Project	<b>IEEE 802.16 Broadband Wireless Access Working Group</b> < <a href="http://ieee802.org/16">http://ieee802.org/16</a> >
Title	<b>OFDMA PHY Configuration and ASN.1 code</b>
Date Submitted	<b>2006-03-09</b>
Source(s)	Joey Chou <a href="mailto:joey.chou@intel.com">[mailto:joey.chou@intel.com]</a> Intel Corporation 5000 W. Chandler Blvd. Chandler, AZ 85226
Re:	
Abstract	This contribution proposed the text and ASN.1 code for OFDMA PHY.
Purpose	Adoption
Notice	This document has been prepared to assist IEEE 802.16. It is offered as a basis for discussion and is not binding on the contributing individual(s) or organization(s). The material in this document is subject to change in form and content after further study. The contributor(s) reserve(s) the right to add, amend or withdraw material contained herein.
Release	The contributor grants a free, irrevocable license to the IEEE to incorporate material contained in this contribution, and any modifications thereof, in the creation of an IEEE Standards publication; to copyright in the IEEE's name any IEEE Standards publication even though it may include portions of this contribution; and at the IEEE's sole discretion to permit others

Figure 7—wmanIfBsPhy structure

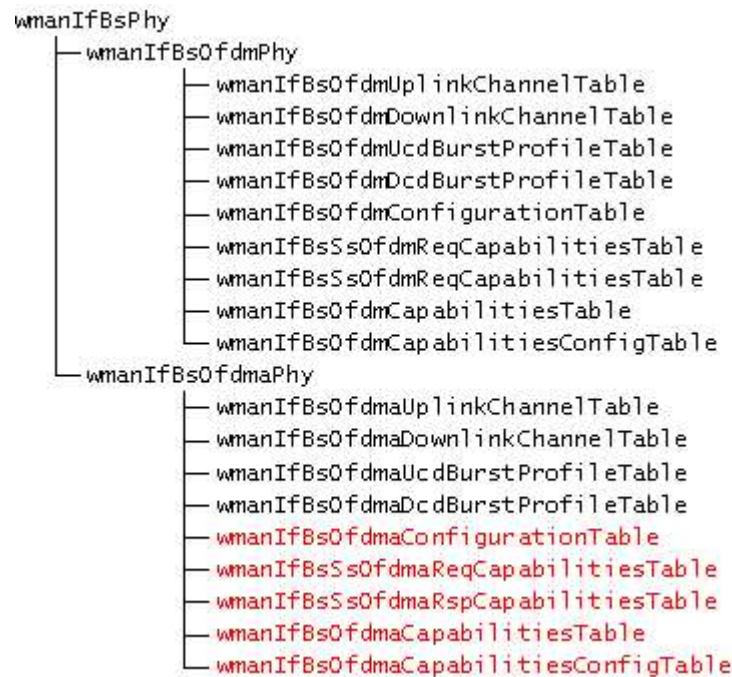
This section proposes new table for OFDMA PHY.

*[Insert a new subclause 16:]*

wmanIfBsOfdmaConfigurationTable contains BS configuration objects, specific to OFDMA PHY.

wmanIfBsSsOfdmaReqCapabilitiesTable contains the basic capability information, specific to OFDMA Phy, of SSs or MSs that have been reported by SSs to BS using RNG-REQ, SBC-REQ and REG-REQ messages. Entries in this table should be created when an SS registers with a BS.

wmanIfBsSsOfdmaRspCapabilitiesTable contains the basic capability information, specific to OFDMA Phy, of SSs or MSs that have been negotiated and agreed between BS and SS via RNG-REQ/RSP, SBC-REQ/RSP and REG-REQ/RSP messages. This table augments the wmanIfBsRegisteredSsTable.

2 wmanIfBsOfdmaCapabilitiesTable contains the basic capabilities, specific to OFDMA Phy, of the  
3 BS as implemented in BS hardware and software.

5 wmanIfBsOfdmaCapabilitiesConfigTable contains the configuration for basic capabilities of BS,  
6 specific to OFDMA Phy. The table is intended to be used to restrict the Capabilities implemented  
7 by BS.
